## EPRI Groundwater Assessment for TVA's Sequoyah Nuclear Plant

### Assessment Final Report

Onsite Evaluation Dates: March 26, 2007 through March 30, 2007

**Figure 2**

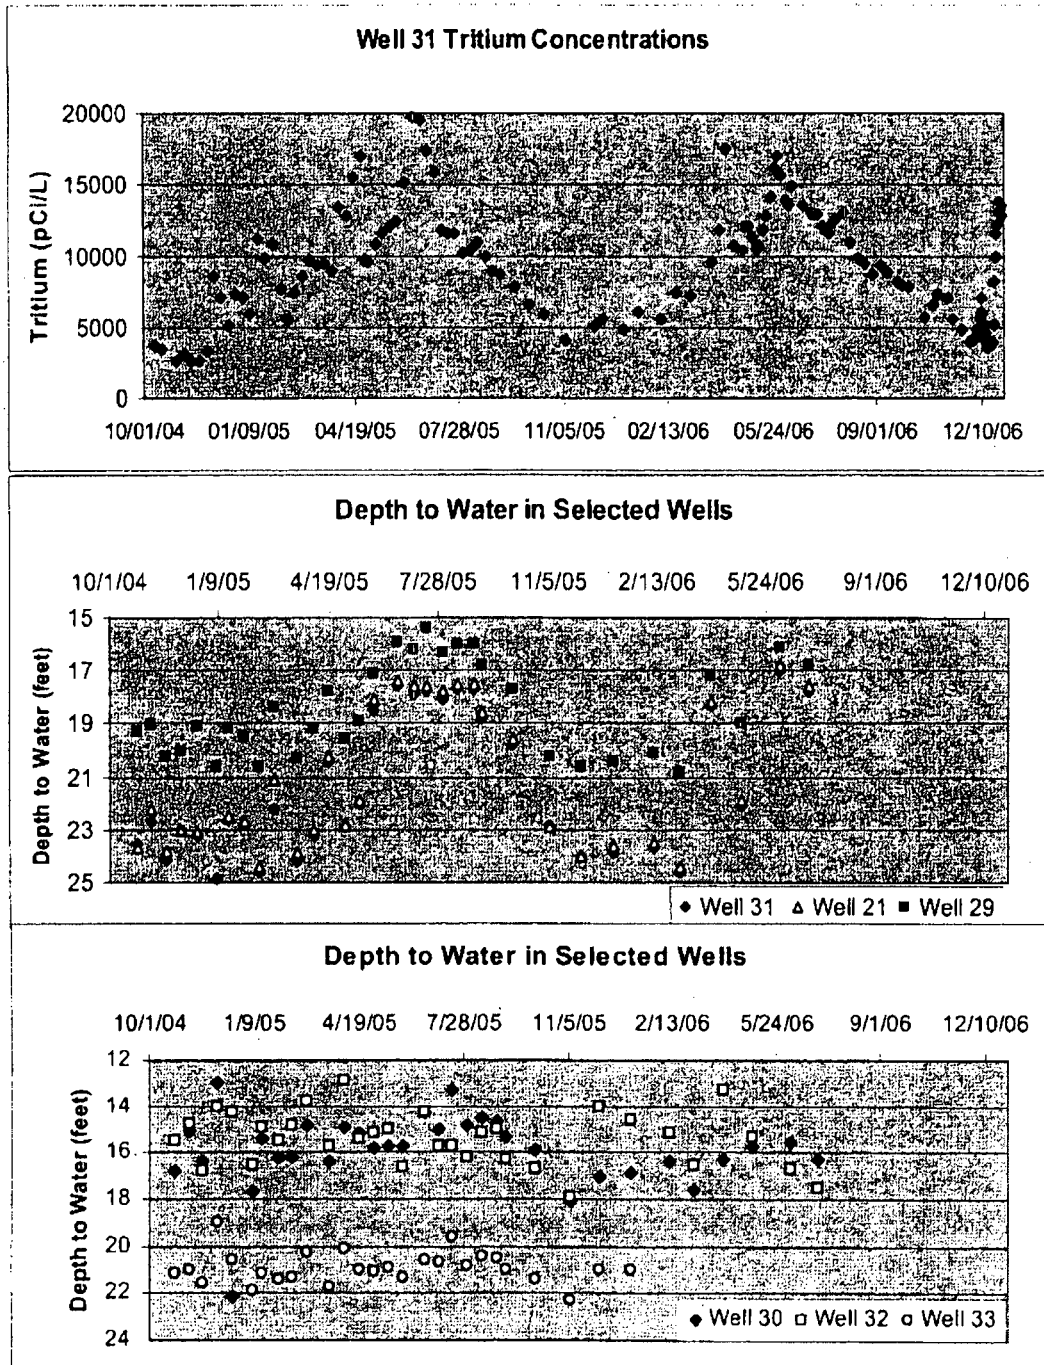
Figures 2 and 3 show the variation in tritium levels in Well 31 during the periods spanning the last two refueling outages in Unit 2 and Unit 1, respectively. These figures show that tritium concentrations in Well 31 are lowest during the outages and increase immediately following the outages. Because the flow of cooling water is reduced during outages, it is likely that the water level in the discharge channel is lower during outages. Lower tritium levels in Well 31 during outages support the conceptual model of rising groundwater remobilizing tritium from historical surface spills that is suspended in the vadose zone.
